ADDENDUM NUMBER 02

**ARPA- CAMPGROUND EXPANSION PROJECTS
A FEDERAL AID PROJECT**

PAWTUCKAWAY STATE PARK

DIVISION OF PUBLIC WORKS PROJECT NUMBER 81205R

S1.01
REVISED

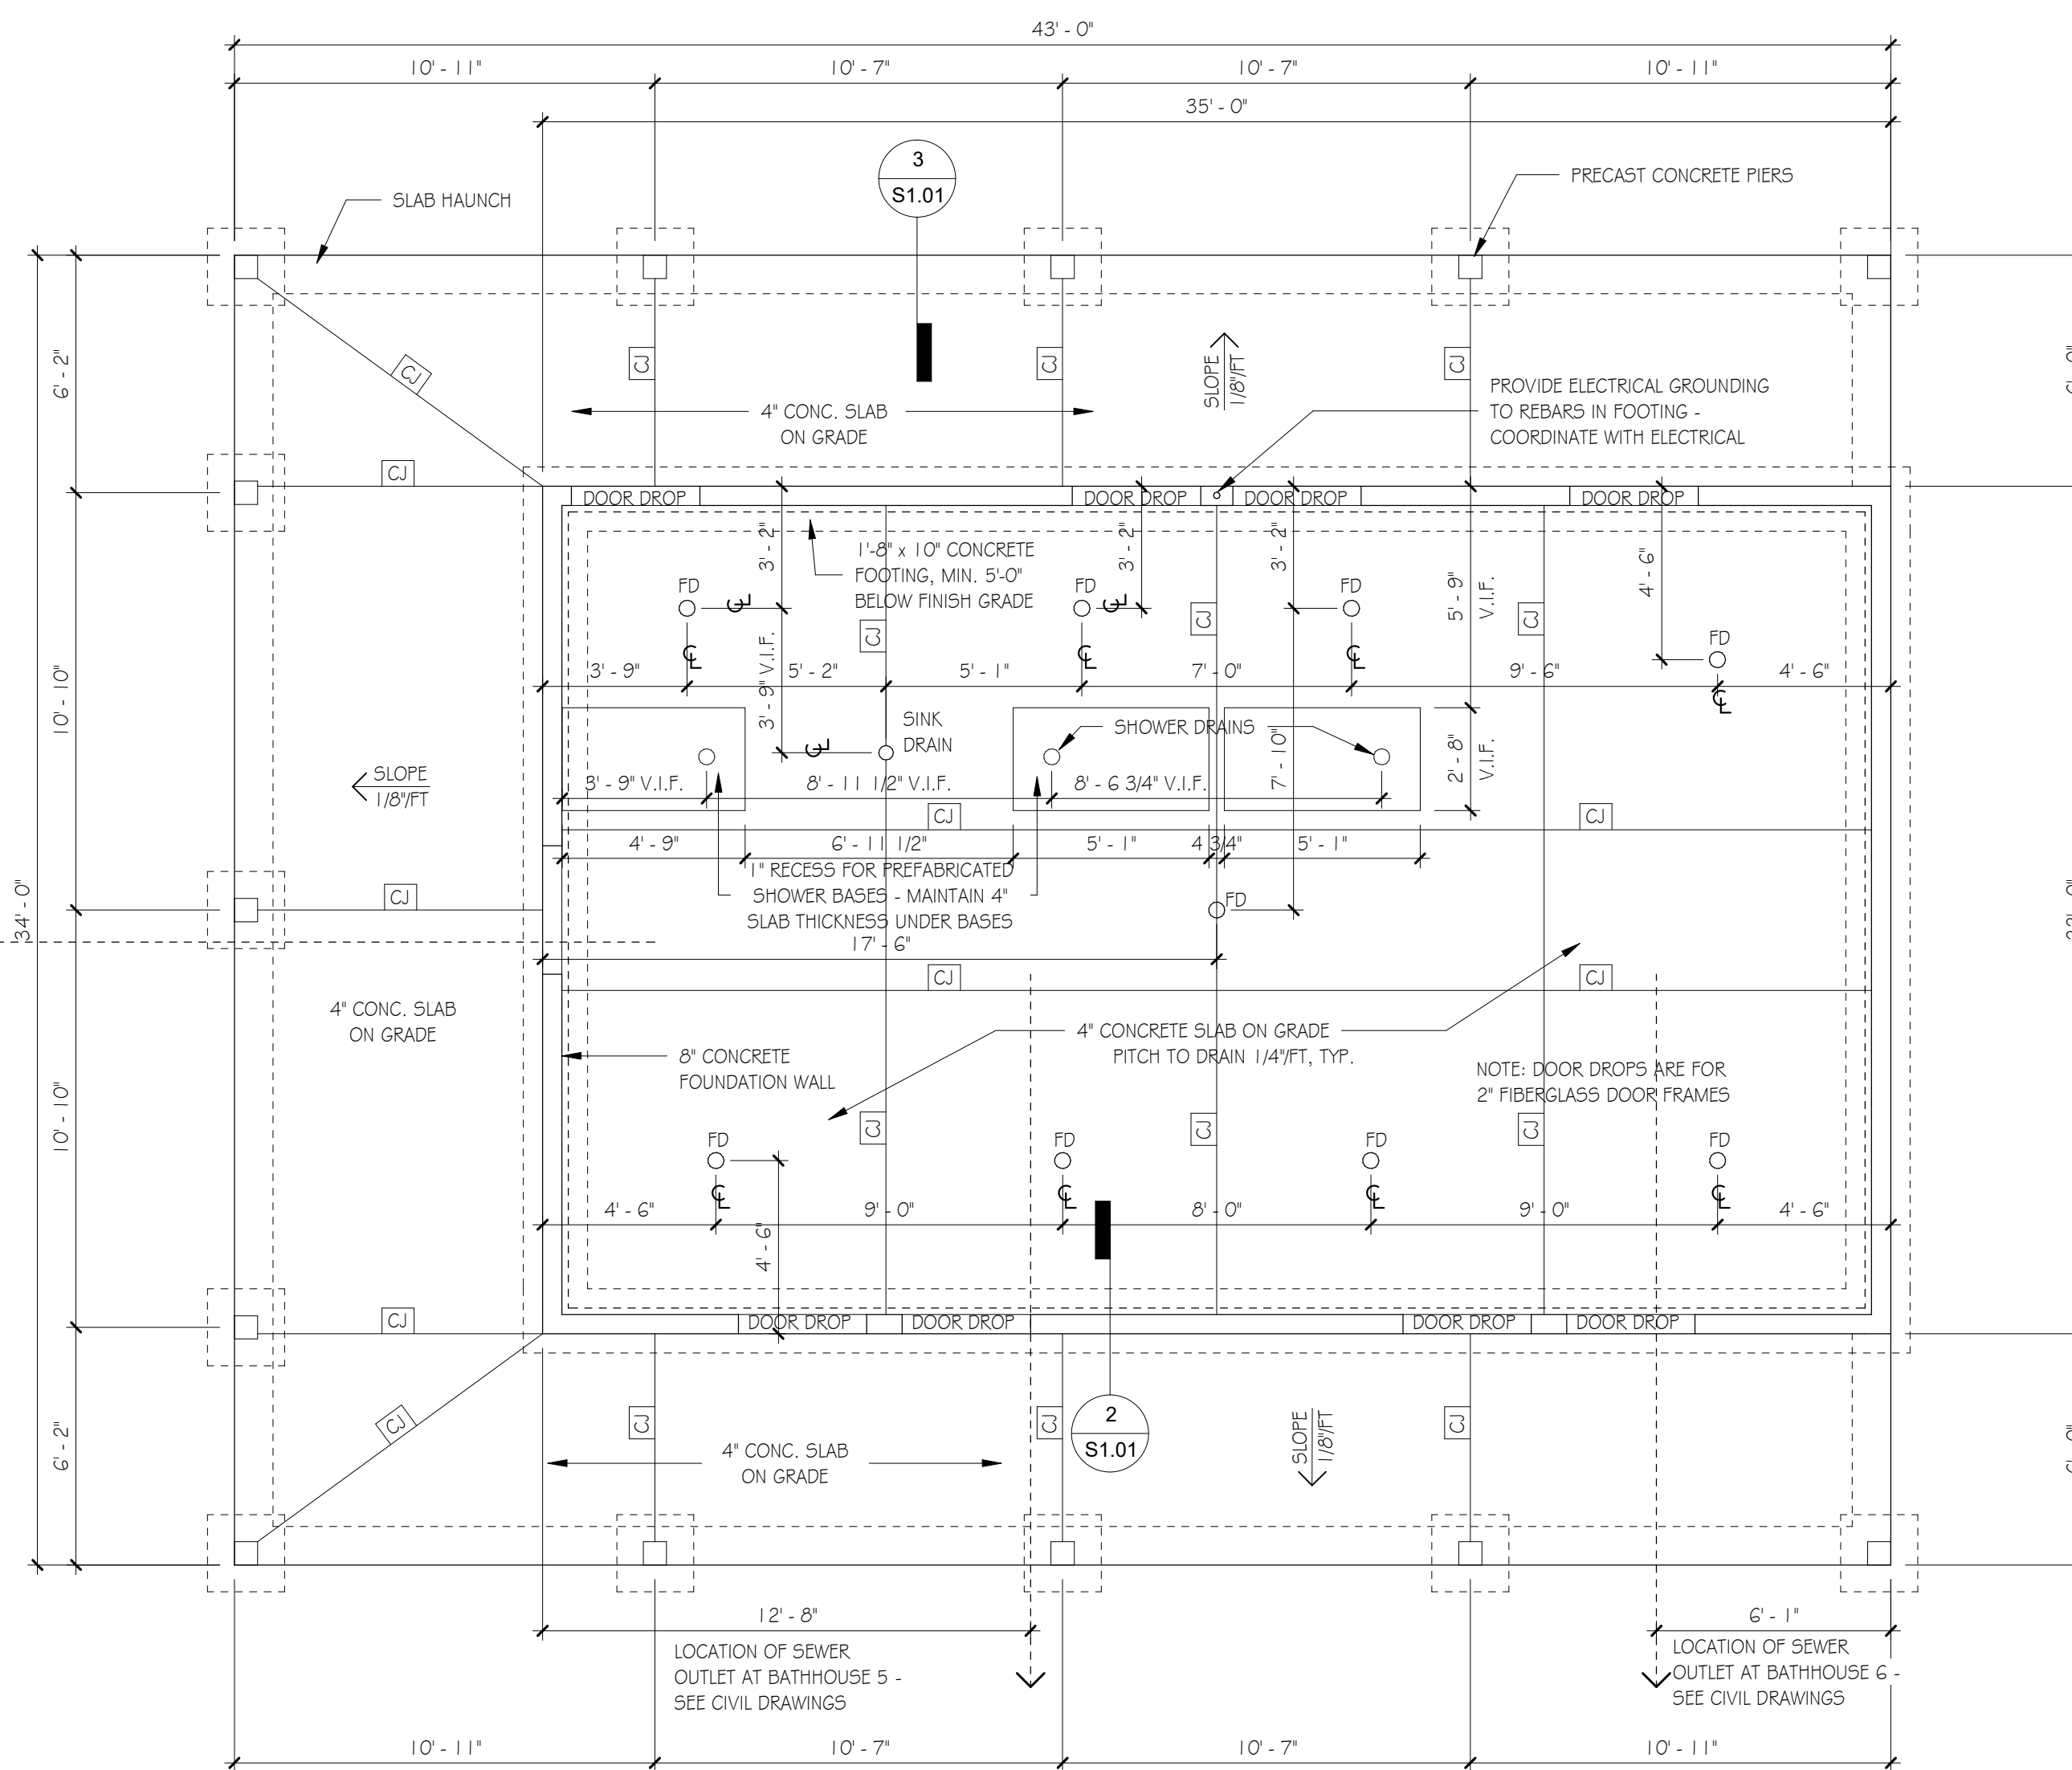
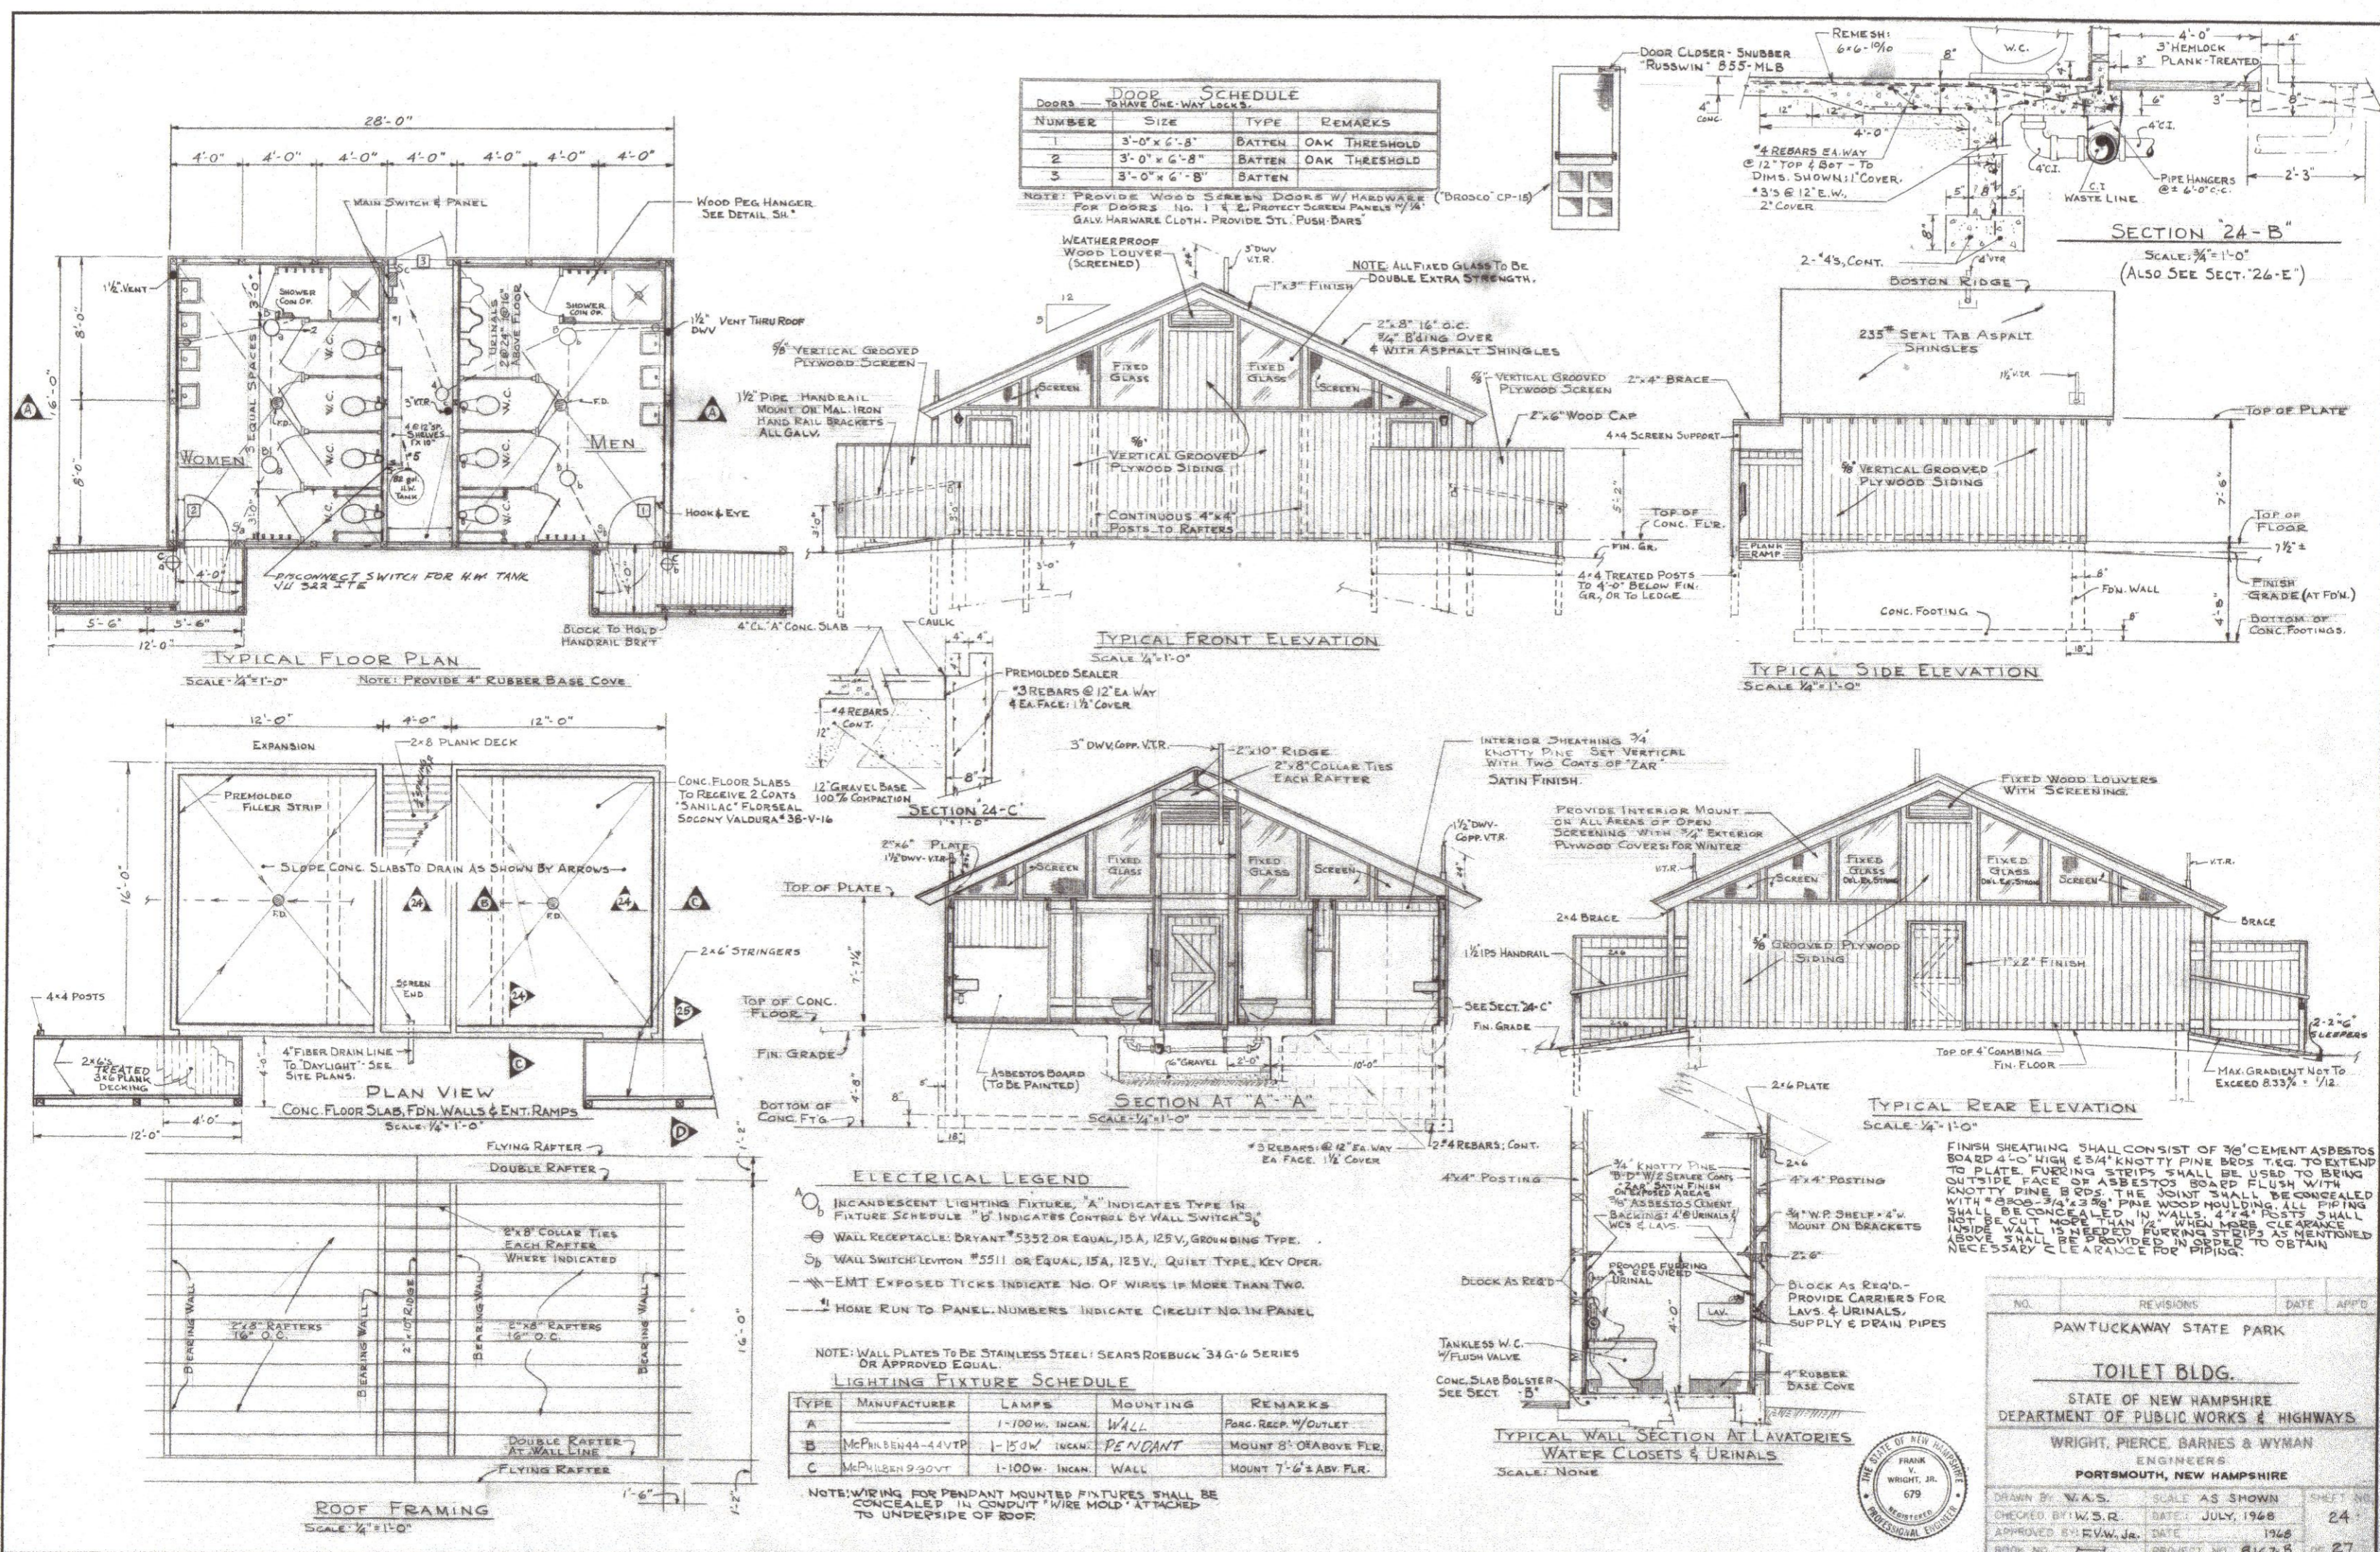
9. Deleted foundation drain.

Response: *Foundation underdrains are not required. See revised sheets A3.01 and S1.01.*
40. Question: Specification 310519.16 Geomembrane Liners. Where is this specification applicable? I do not see any areas noted for geomembrane liners.
